*Rogerson & Birch Surveyors – Proposed Subdivision Plan,  
Overlay Plan and Falls Site Building Plan*

*Agricultural Report and Peer review*

**PLANNING APPEAL – 255 MARCHWIEL ROAD, BREAM CREEK  
SECRET SOUNDS GROUP PTY LTD V SORELL COUNCIL - P/2025/13**

# Marchwiel Road Dam Feasibility Report

<b>Date:</b> 13-07-2022	<b>Reference:</b> QUINB01 14425-03
<b>Scale:</b> 1:10,000 (A3)	<b>Municipality:</b> Sorell

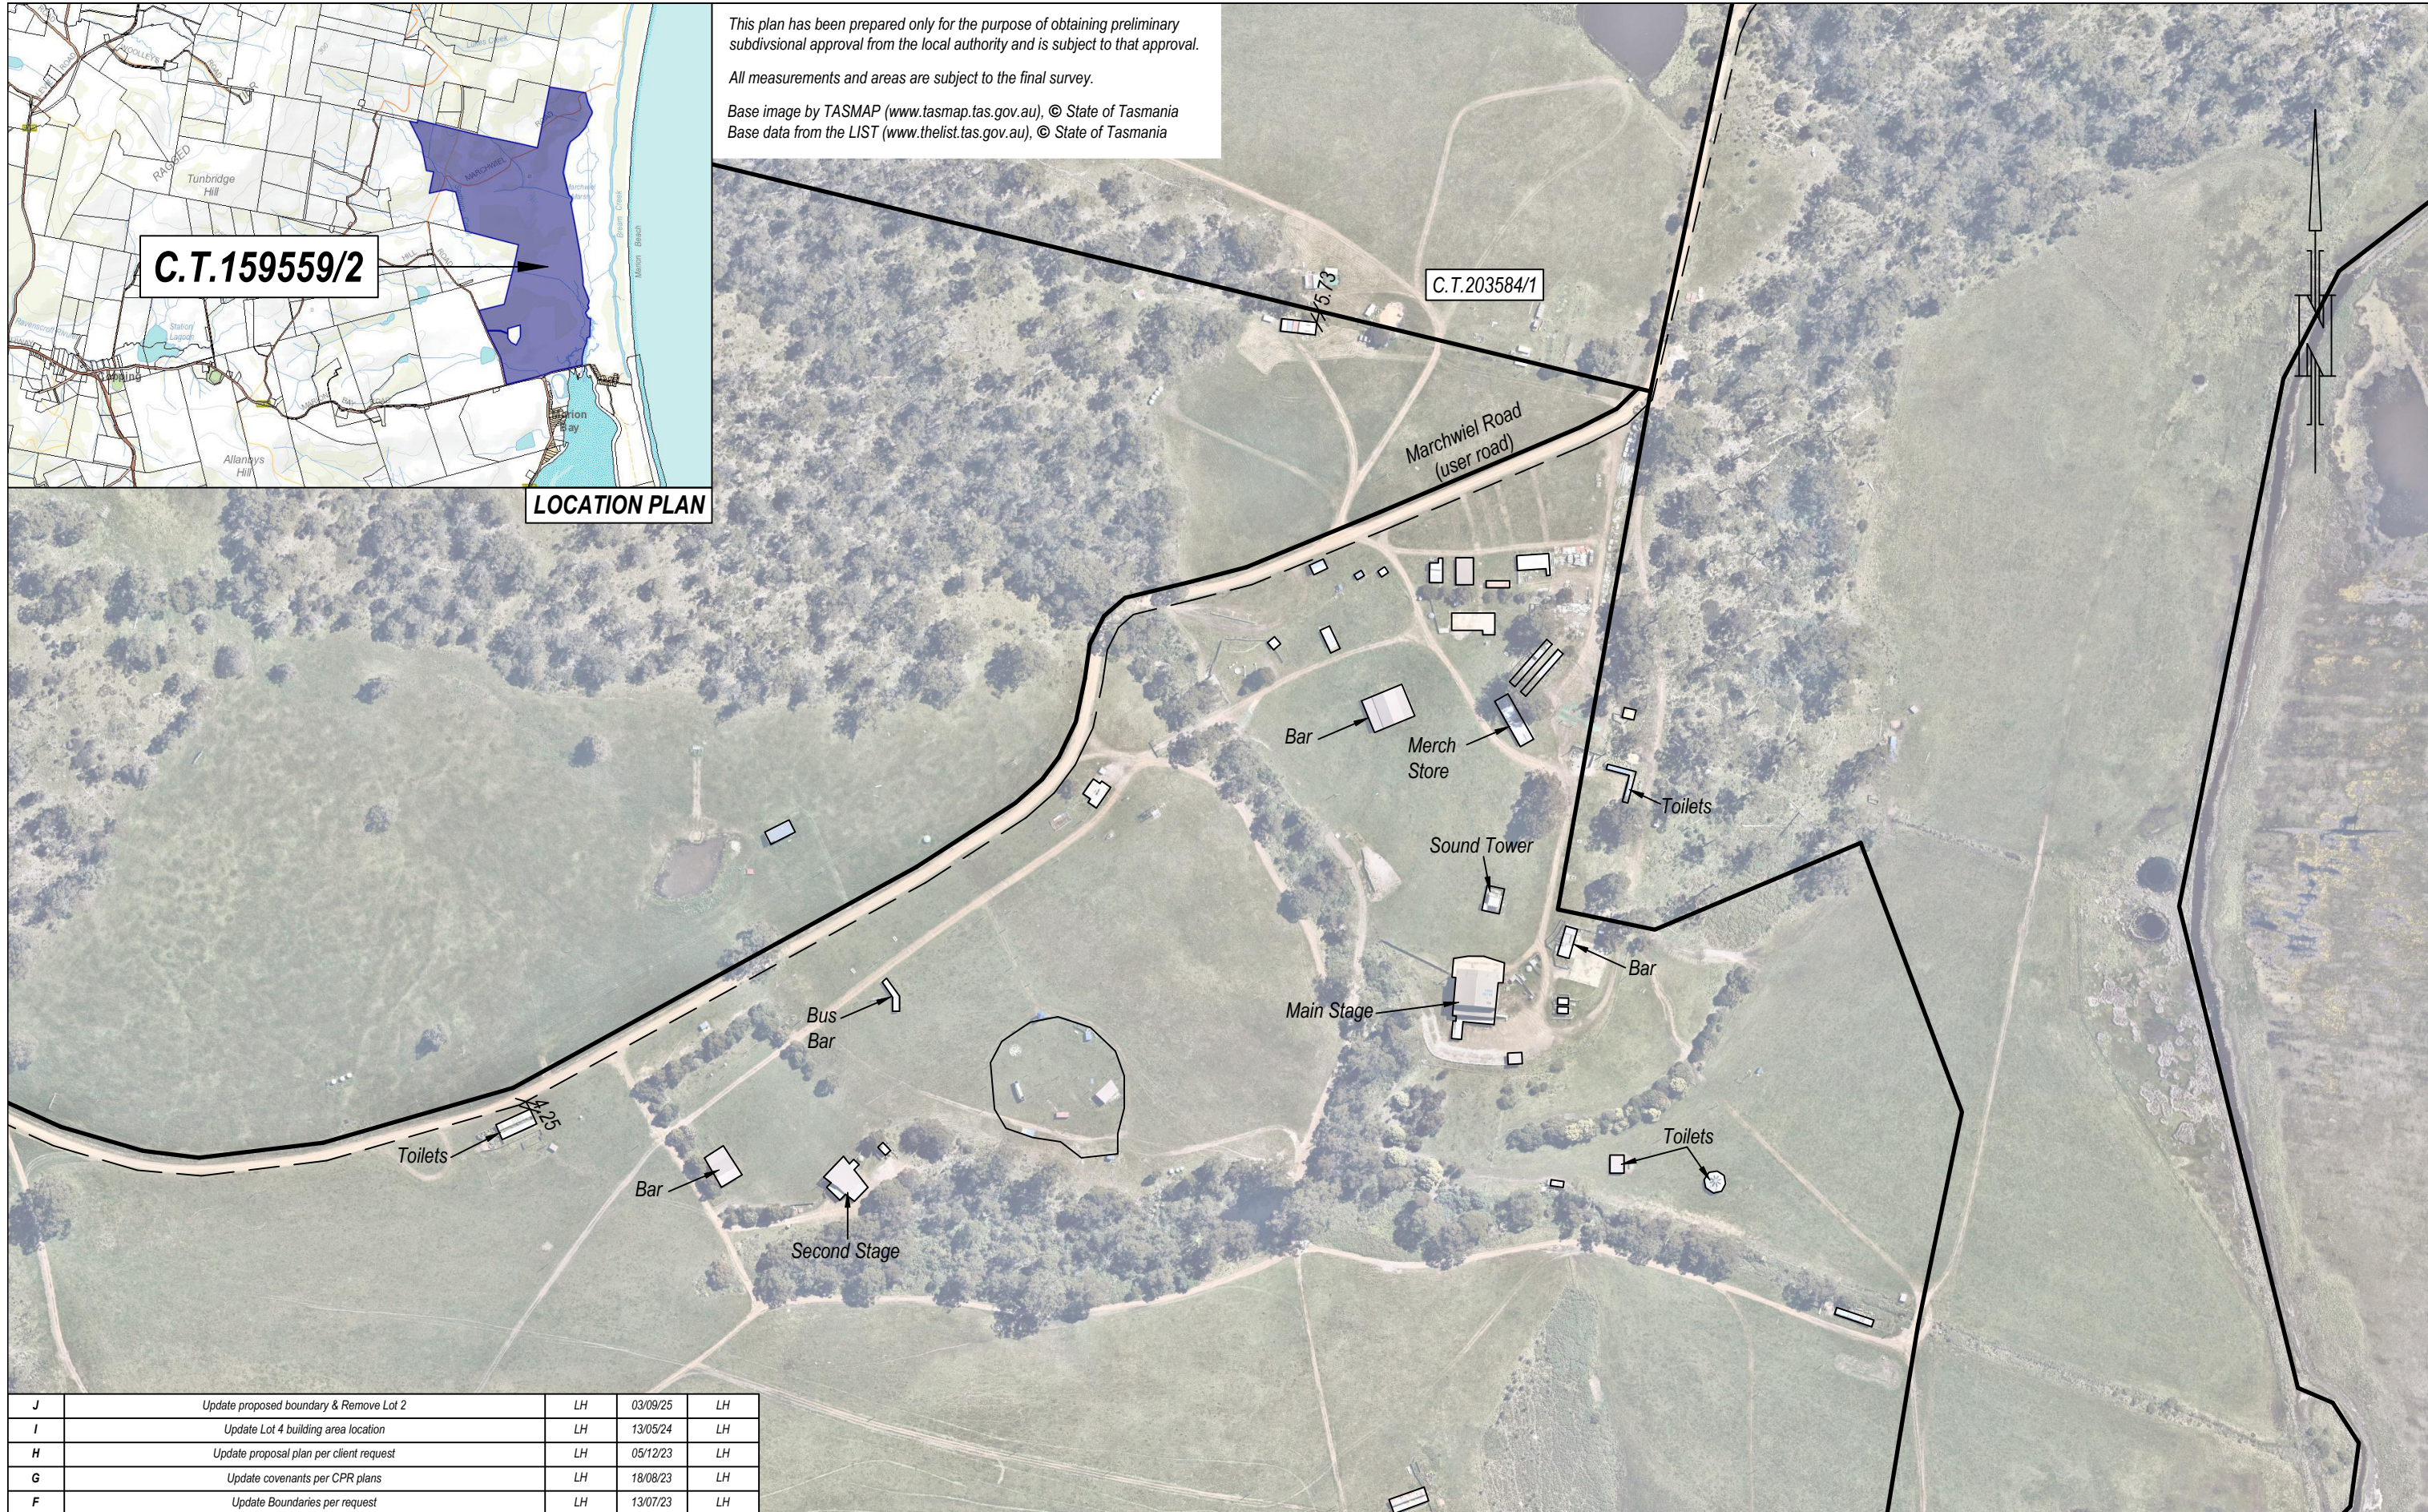
**Attached** to this correspondence is a revised plan of subdivision that shows Lots 1 and 2 to be combined as a single lot, now numbered Lot 1. The boundary between what is now Lot 1 and Lot 3 has been adjusted to increase the area of flat pasture to be accommodated within Lot 1 while still maintaining sufficient land within Lot 3. As discussed, my client's preferred future for Lot 3 is to retain this lot and develop a vineyard/cellar door site.

Lot 3 is reduced in area from 53.2ha to 47.7ha. The selected boundary now follows the easement over the property, with the easement to be located wholly within the area of Lot 1.

Figure A1-3: Site plan of proposed 4-lot subdivision. By Rogerson and Birch Surveyors

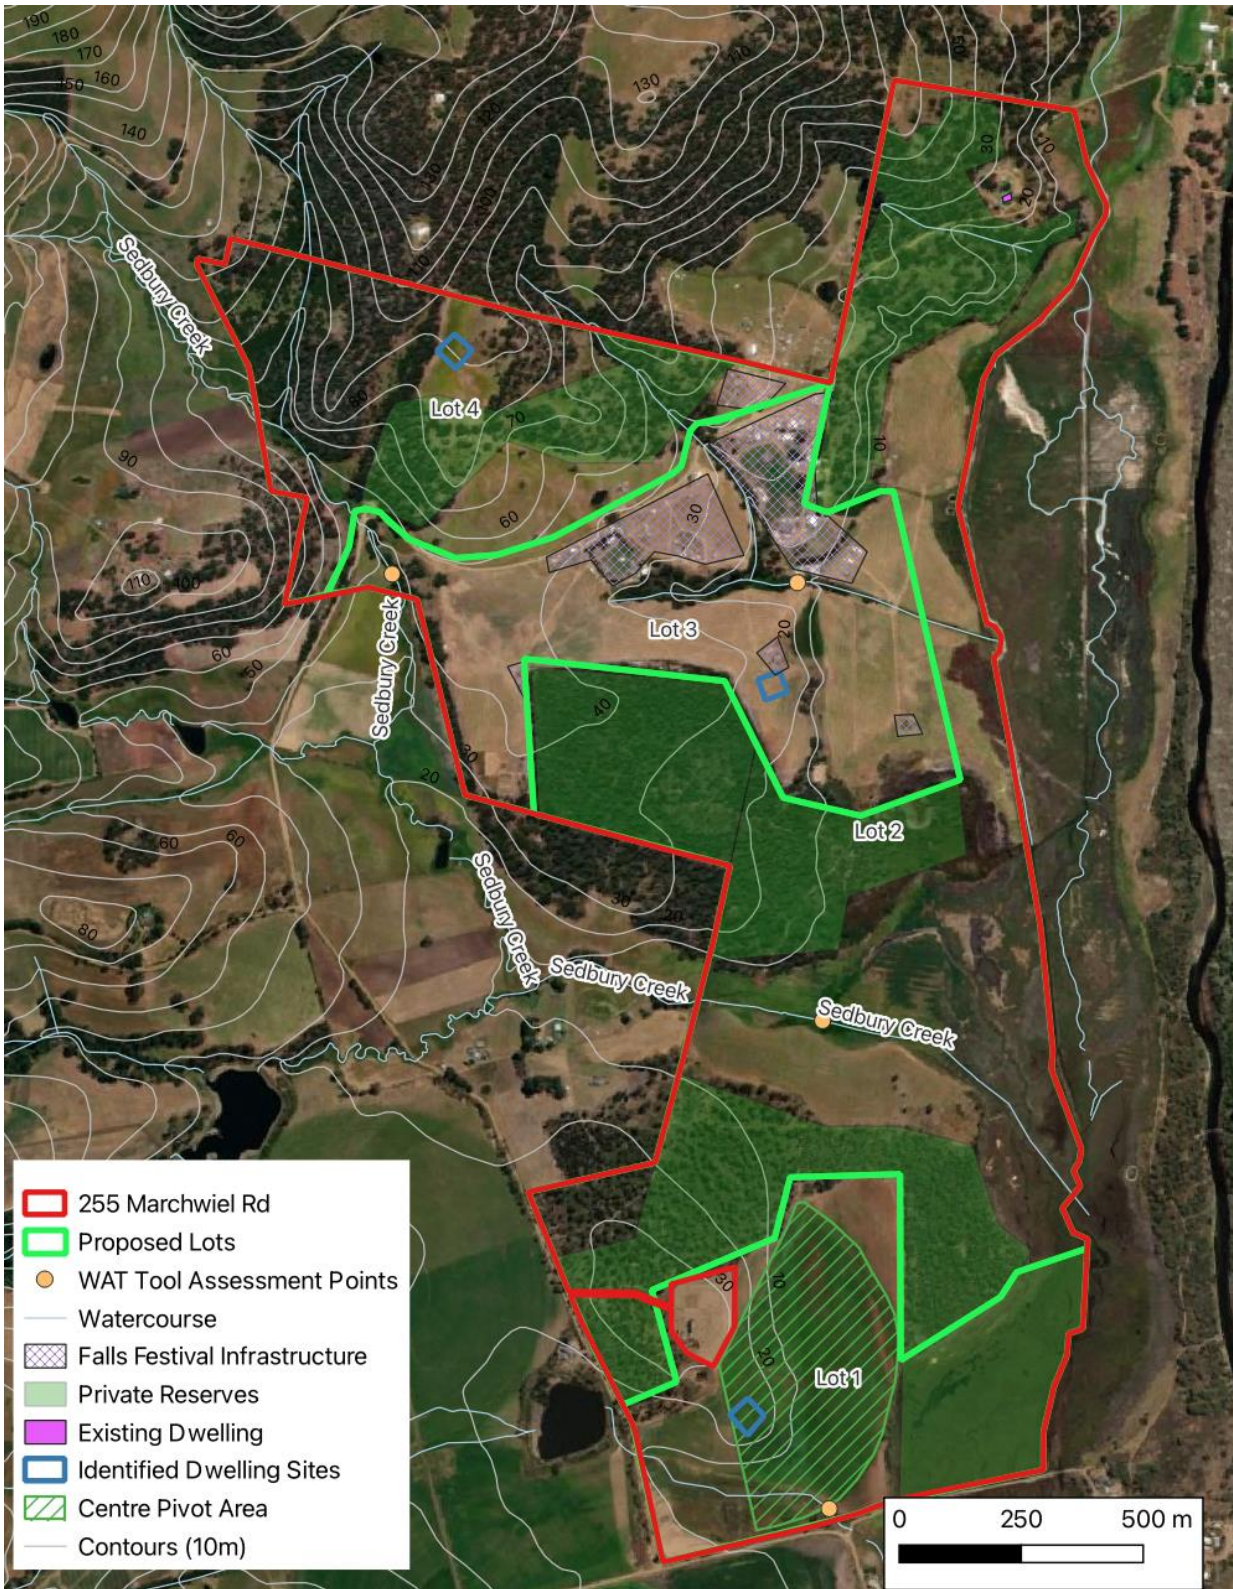
As shown on the proposed subdivision's site plan (Figure A1-3), there is an existing pipeline easement that traverses the subject site. This pipeline provides Bream Creek Dairy access to a water resource they have rights to further to the north. There may be opportunity for the subject site to access this water, however this would be subject to negotiations with the Bream Creek Dairy.

It also increases the potential for further dwellings to be constructed as shown on the site plan (see Figure A1-3) which further reduces the likelihood for the area to be utilised for commercial agricultural activities.
